# Access Compliance Report

## Public Rights-of-Way

### (Curb Ramps)

Intersection ID: 8867	Main Street: GRANT_ST	Cross Street: LANDER_ST	Location: S
ADA ID: 15B86BACC5D7	Ramp Type: Perp	Initial Pass/Fail: Fail	Overall Compliance: No
Severity Score: 10			
Codes/Mitigation Info/Possible Solution		Field Measurements/Component Compliance

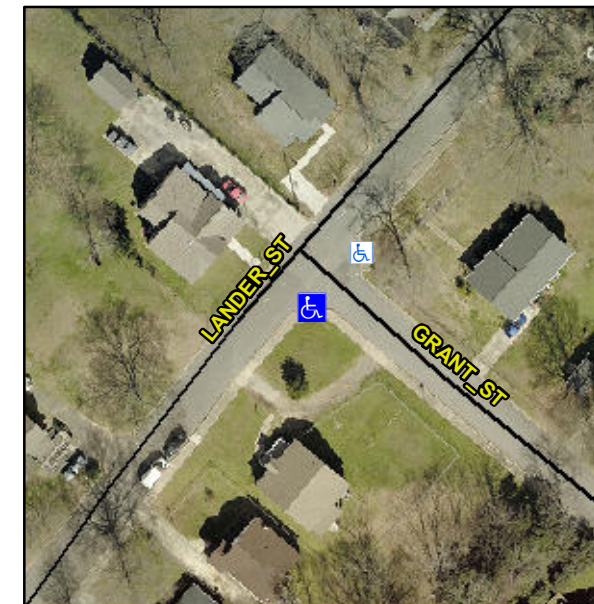
**Not Found, R304.5.1, R304.5.3**

Compliance	Description	Data	Compliance	Description	Data
N/A	Ramp Length (in)	55.5	Yes	Ramp Slope (%)	7.2
No	Ramp Width (in)	47.5	No	Ramp XSlope (%)	2.1
N/A	Flare Type LT	N/A	N/A	Flare Type RT	N/A
N/A	Flare Slope LT (%)	N/A	N/A	Flare Slope RT (%)	N/A
N/A	Flare Traversable LT?	N/A	N/A	Flare Traversable RT?	N/A
N/A	Landing Length (in)	N/A	N/A	DWS Provided?	N/A
N/A	Landing Width (in)	N/A	N/A	DWS Contrast?	N/A
N/A	Landing Slope (%)	N/A	N/A	DWS Length (in)	N/A
N/A	Landing X Slope (%)	N/A	N/A	DWS Full Width?	N/A
N/A	Landing Curb? (Y/N)	N/A	N/A	DWS Offset (in)	N/A
N/A	Shared Landing?	N/A			
N/A	Gutter Ponding?	N/A	N/A	Gutter Slope (%)	N/A
N/A	Gutter Lip Ht (in)	N/A	N/A	Gutter X Slope (%)	N/A
N/A	Painted X Walk1?	No	N/A	Painted X Walk2?	N/A
	X Walk 1 Direction	To NE		X Walk 2 Direction	N/A
N/A	X Walk 1 Width (in)	N/A	N/A	X Walk 2 Width (in)	N/A
	X Walk 1 Slope (%)	2.5		X Walk 2 Slope (%)	N/A
	X Walk 1 X Slope (%)	1.4		X Walk 2 X Slope (%)	N/A

**Remove & Replace Entire Ramp.**
